**Merri-bek**  
City Council

# **Activity Centres Program Phase 2: Technical paper**

**October 2025**

Figure 1 - Map showing recommended changes to the core AC boundaries

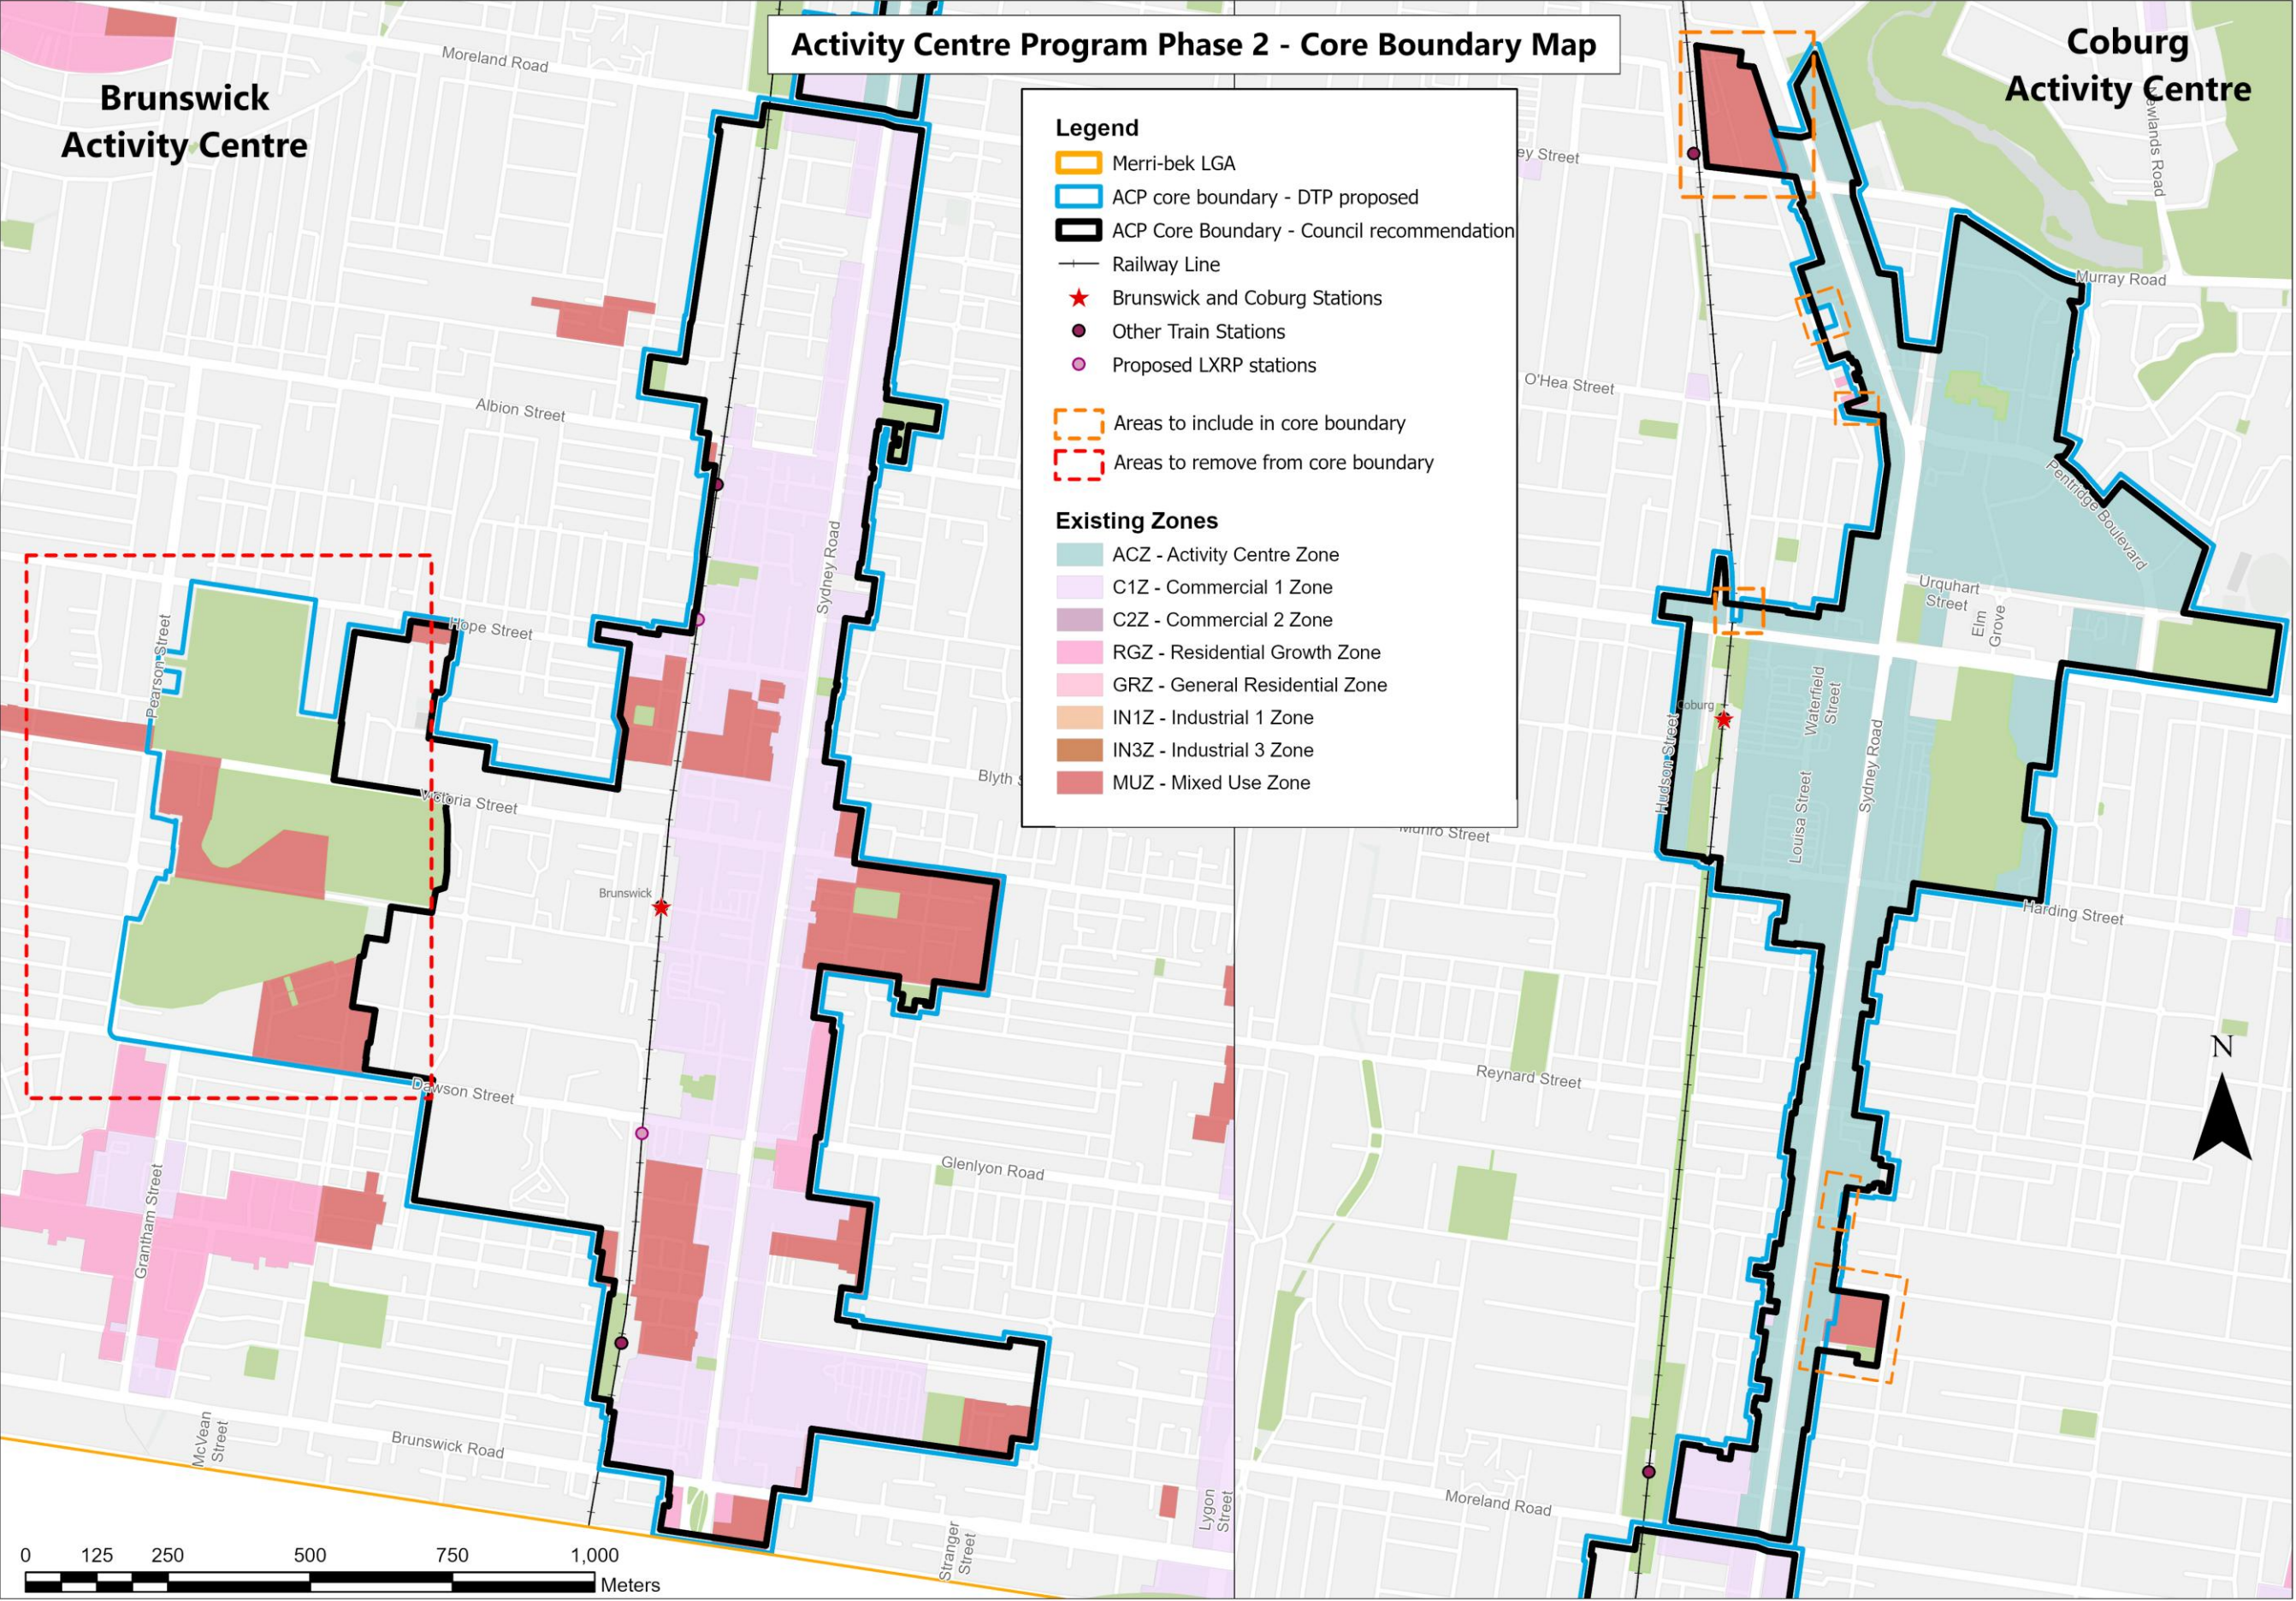
It is recommended that these core boundaries are modified as reflected in Figure 1. These changes represent both expansion and reductions in areas, as described in Table 2.

**Brunswick** Align the core boundary with the Brunswick AC boundary in C230mbek (Sydney Road corridor).

This extent would exclude the Central Brunswick Parklands and surrounding Mixed Use Zone (MUZ) sites, sites that are largely developed (or in benefit of a planning permit), disconnected from the core commercial and civic activity along Sydney Road and located more than 600m from the rail corridor.

**Coburg** Expanding the core boundary to include two large MUZ sites at 31 The Avenue and 14–22 Gaffney Street, Coburg located adjacent to the current Coburg AC extent. These sites are well-positioned for inclusion due to their strategic location, development opportunity and compatibility with the intended built form outcomes.

- 31 The Avenue has an approved permit for 8-storey development, demonstrating its suitability for higher-density development. Inclusion would also resolve the current lack of built form guidance to the site and ensure consistent built form guidance suitable to the scale envisaged for the site
- 14-22 Gaffney Street is a large, strategically located adjacent to Batman Station and aligns with the scale and character of the core area.

Including all properties within the current Coburg ACZ and the full extent of 613–625 and 653 Sydney Road Coburg to have a consistent zone application to their entire sites.

Clarifying the status of the Pentridge area, as its inclusion in the core boundary without being in the BFO creates inconsistency.

**Figure 3 – Off-corridor area in the Brunswick AC comparing the Phase 2 proposed heights with City of Centres maximum heights based on lot width methodology to the off-corridor area in the Brunswick AC**

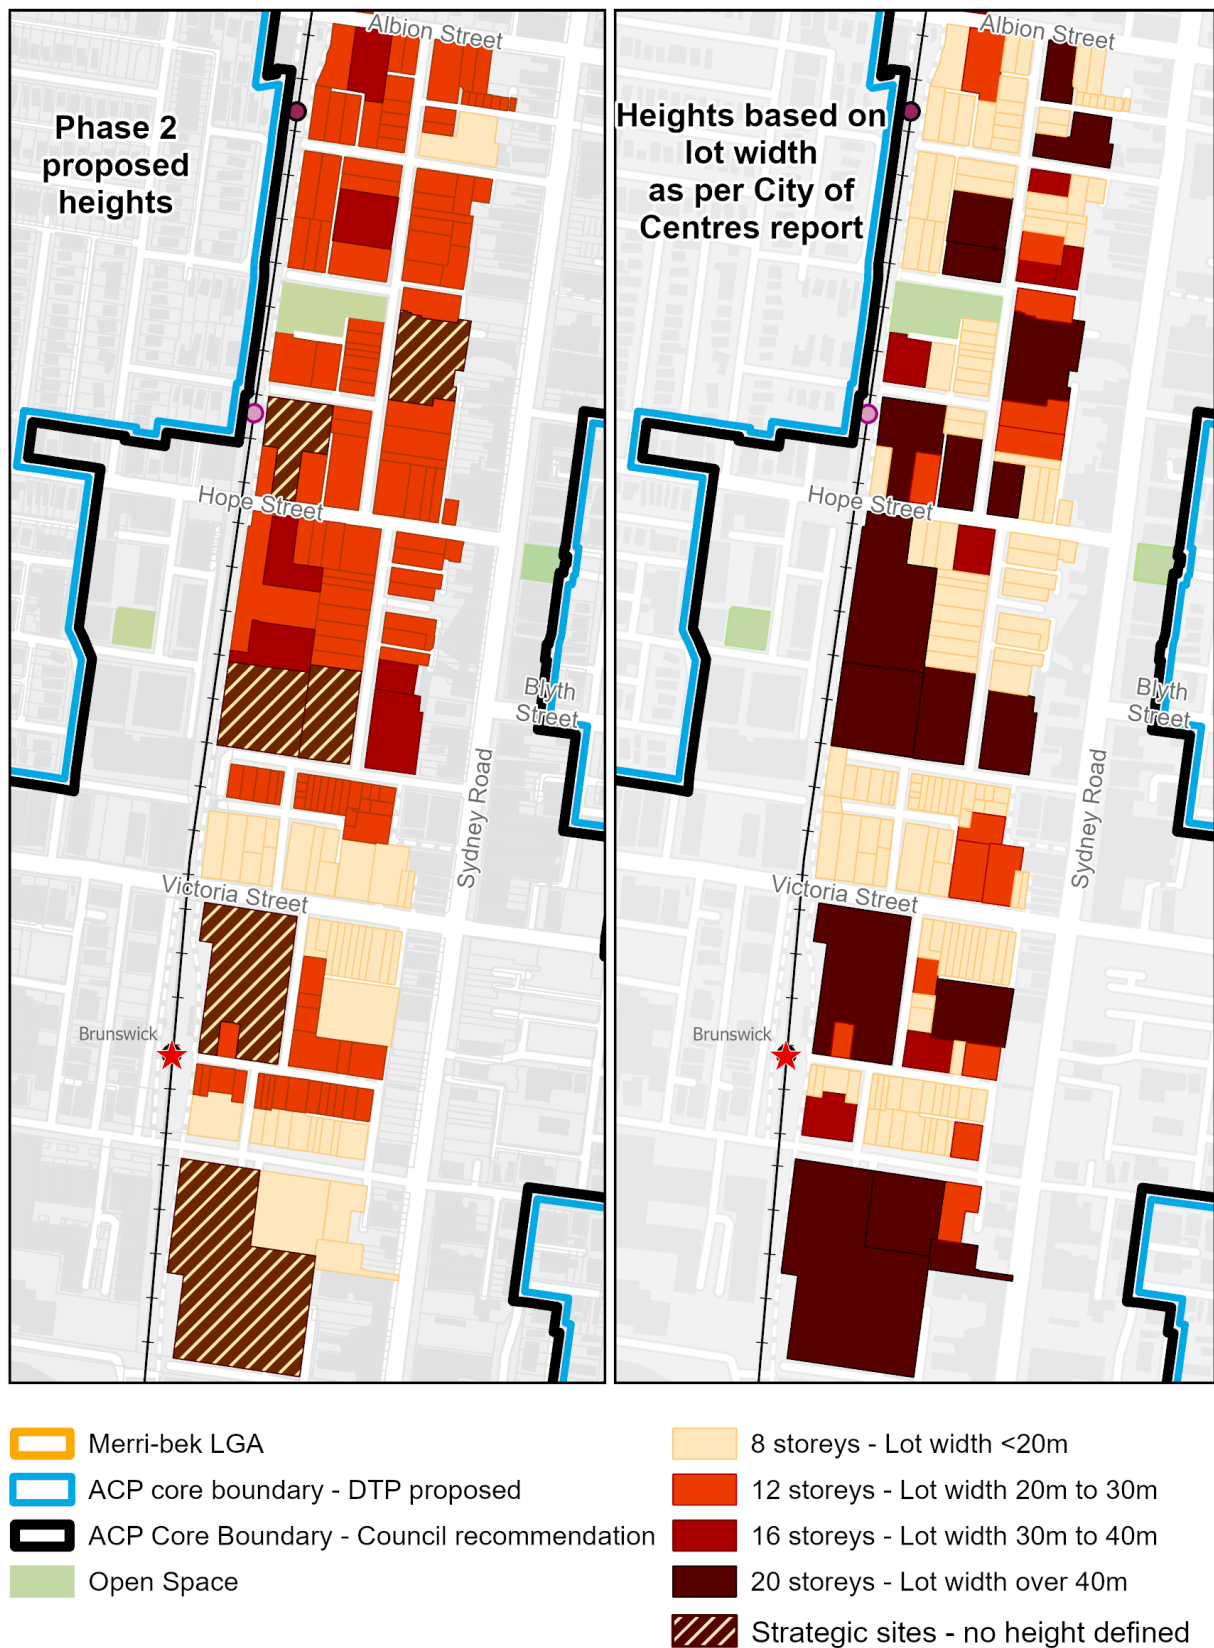
The City of Centres offers a methodology in Figure 2 related to maximum heights to lots in a range of 8 storeys to 20 storeys. Using this methodology for a desktop comparison with the Phase 2 proposed heights in the off-corridor section of the Brunswick AC between Albion Street and Victoria, it illustrates a substantial difference between the two (Figure 3). In particular, that there are a substantial number of narrow lots, and that even with some lot consolidation, the heights are likely unachievable given site sizes and the context.

It is therefore imperative that proposed deemed to comply heights are linked to compliance with standards on street wall height, upper-level setbacks, side and rear setbacks, setbacks to sensitive interface, building separation and sunlight protection.

Figure 4 – Map comparing Phase 2 proposed heights and Council recommended heights for the Coburg AC

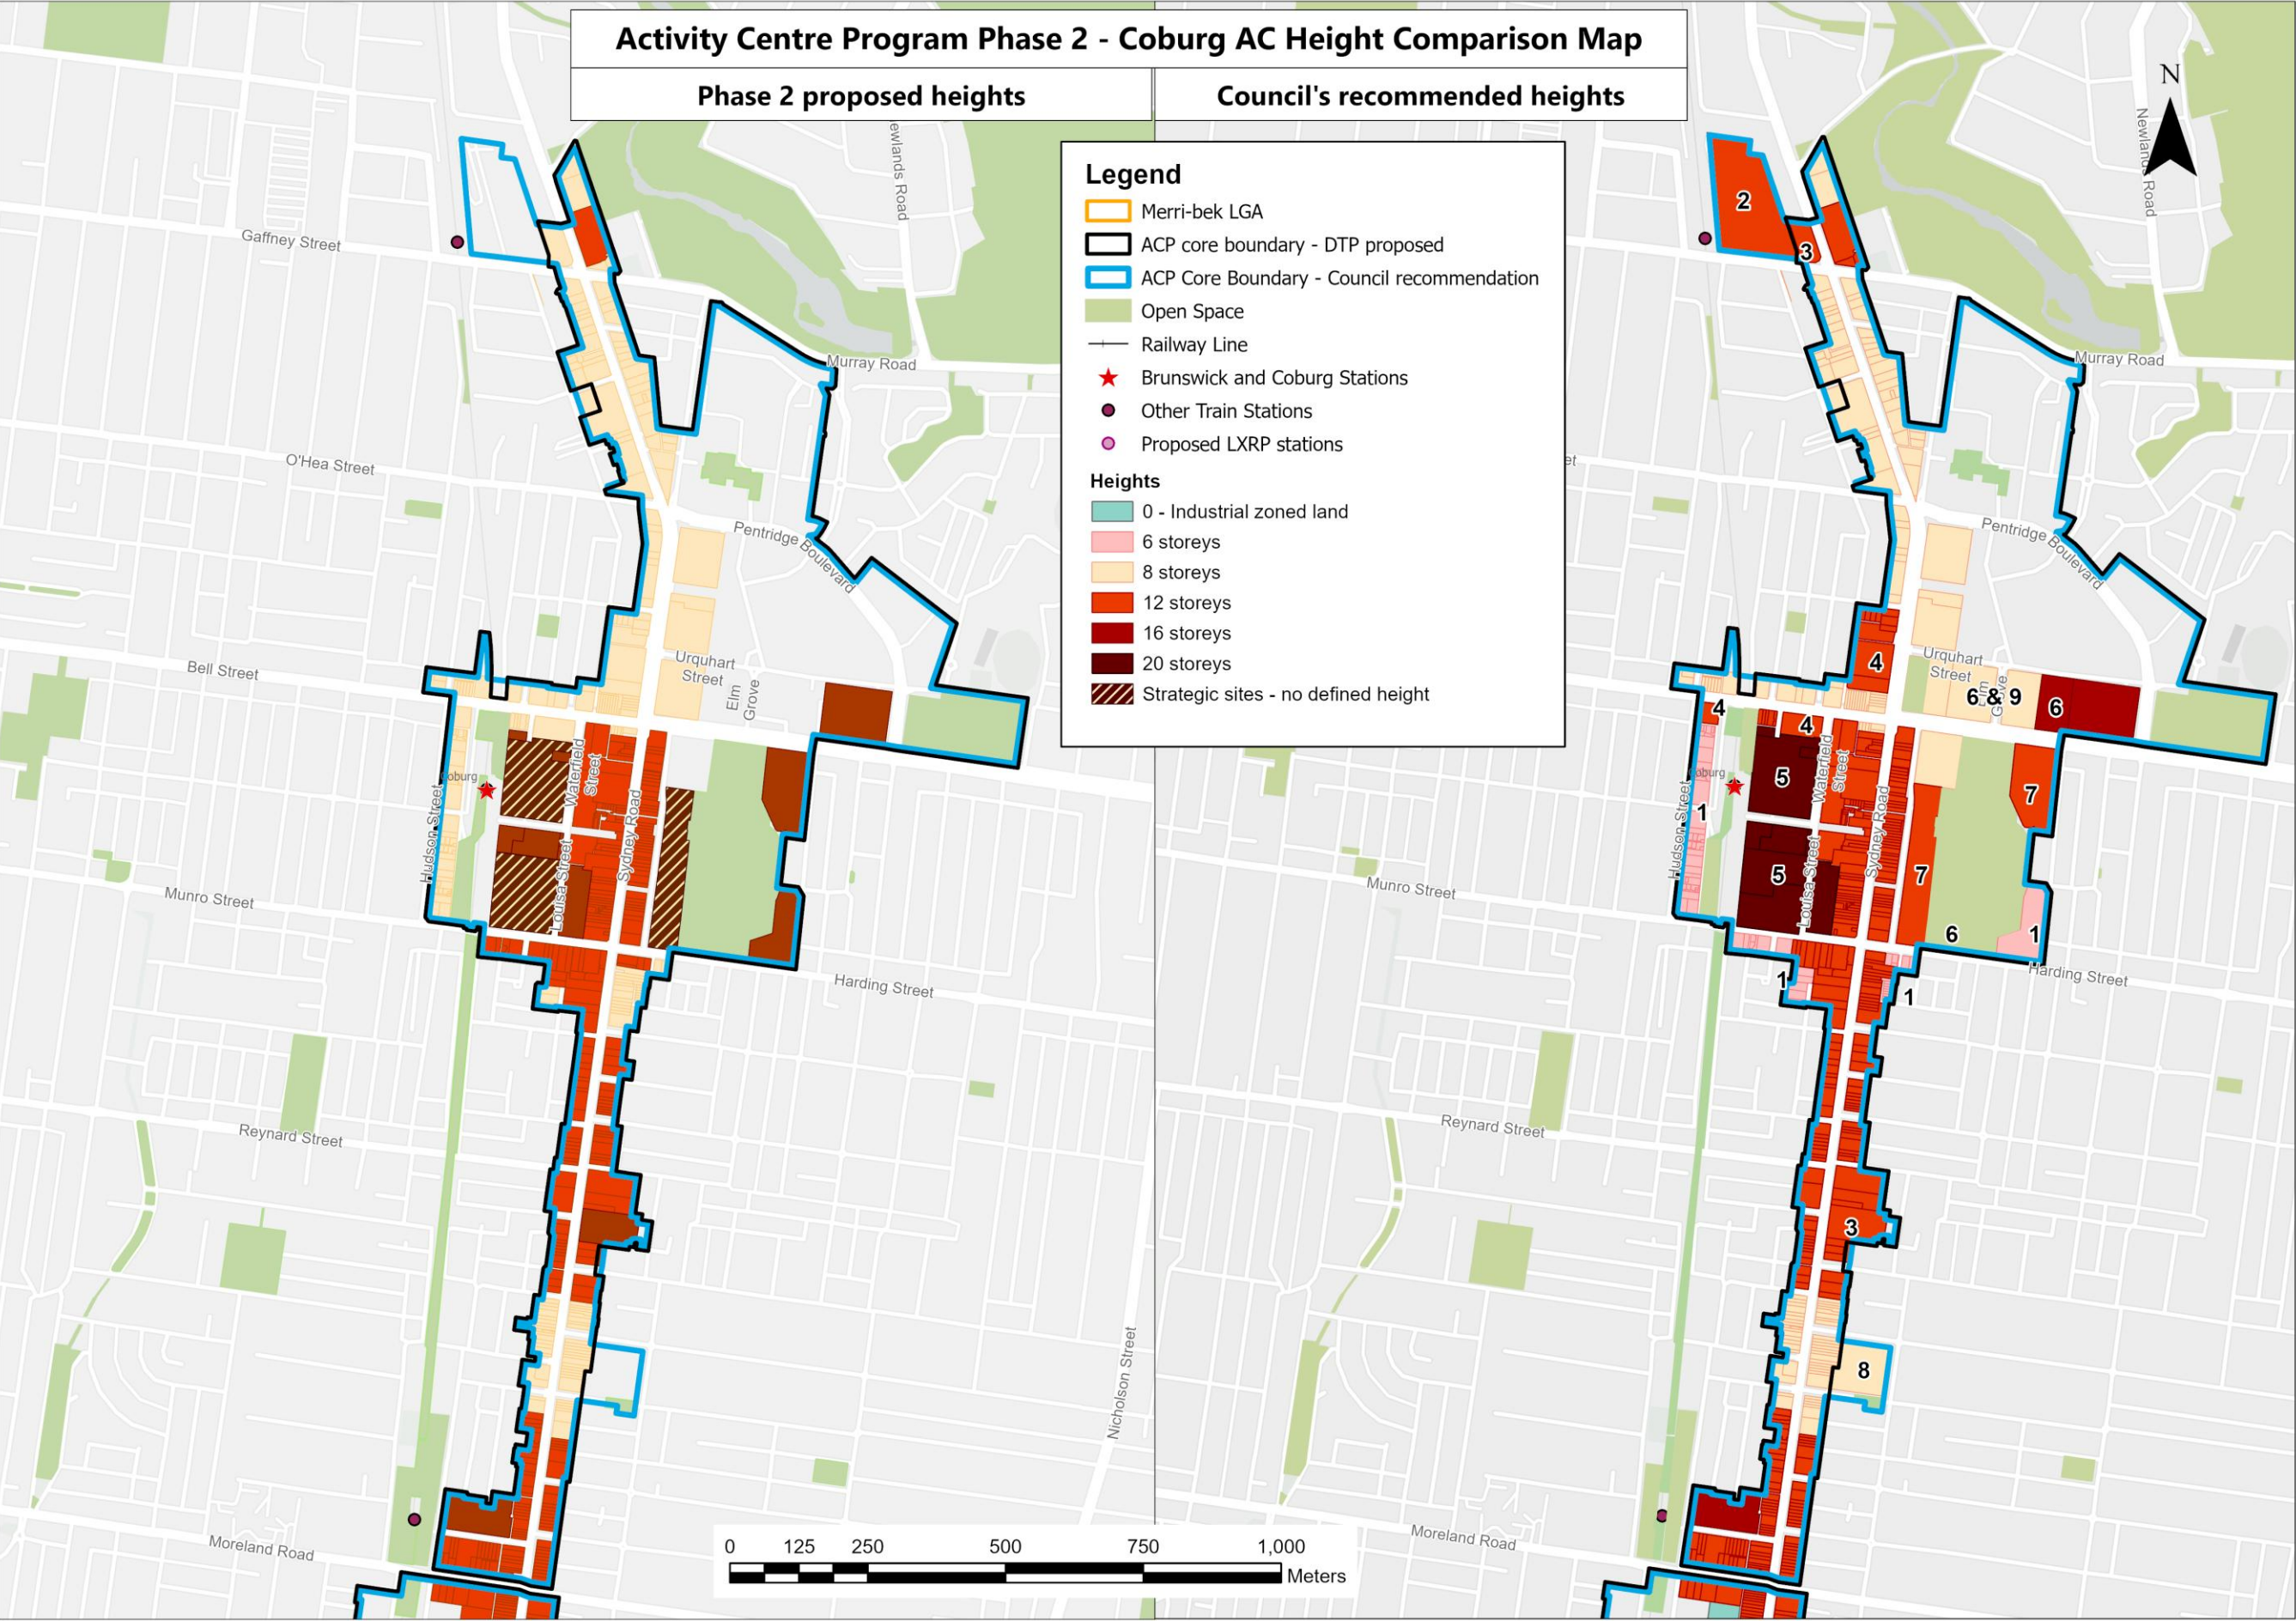
Figures 4 & 5 illustrate Council's recommended changes to building heights within the AC's core, with Table 3 providing additional rationale for the changes. This feedback should be considered indicative, as it has been provided without the benefit of comprehensive testing against key urban design metrics that would confirm the heights are achievable.

| 2 | <b>Large site adjacent to train station</b> | 14-22 Gaffney Street Coburg is suitable to be within the Coburg AC core boundary given its size and excellent access to both train and tram services. It is a large site of more than 26,000m <sup>2</sup> in size and is positioned next to the Batman railway station and a short distance to tram services along Sydney Road. Its orientation and location with a robust southern and western interfaces suit the scale envisaged for the Coburg AC and aligned with 664-716 Sydney Road Coburg. The proposed height in HCTZ1 is lower than the preferred height in the existing scheme.                                                                                                                                                                                                                                                                                                                                                                                                                                                                                                                                                                                                                                                                                                                                                                                                                                                                                                                                                                                                                |
| 3 | <b>Consistent height application</b>        | <p>Recommending a consistent height be applied to these sites and areas as follows:</p> <ul style="list-style-type: none"> <li>• 737-757 Sydney Road Coburg should reflect the same height as 664-716 Sydney Road Coburg and 14-22 Gaffney Street Coburg given their similar contexts and limited sensitivities.</li> <li>• 200-216 Sydney Road Coburg should match the 12-storey height directed to this section of Sydney Road, which is consistent with the scale of the apartment building currently being constructed on that site.</li> <li>• The off-corridor precinct in Brunswick between Albion and Victoria Street to have a consistent height application given their similar context and for streetscape consistency.</li> <li>• Merri Street and Dods Streets Brunswick present with constrained urban environment characterised by narrow streets and predominantly small lots that will constrain development potential for large developments. A clear example is the 4-5 storey apartment building at 18 Merri Street. Despite being on a large site, the buildings scale was influenced by the need to manage off-site impacts, particularly on surrounding narrow streets, nearby parks and existing housing.</li> <li>• Properties on the west side of Frith Street to have a consistent height application across the entire street.</li> <li>• 201 Albert Street Brunswick has been recently developed with a 6-storey apartment building that pushes the boundary on scale to ensure the streetscape, nearby parks and surrounding dwellings amenity can be maintained.</li> </ul> |
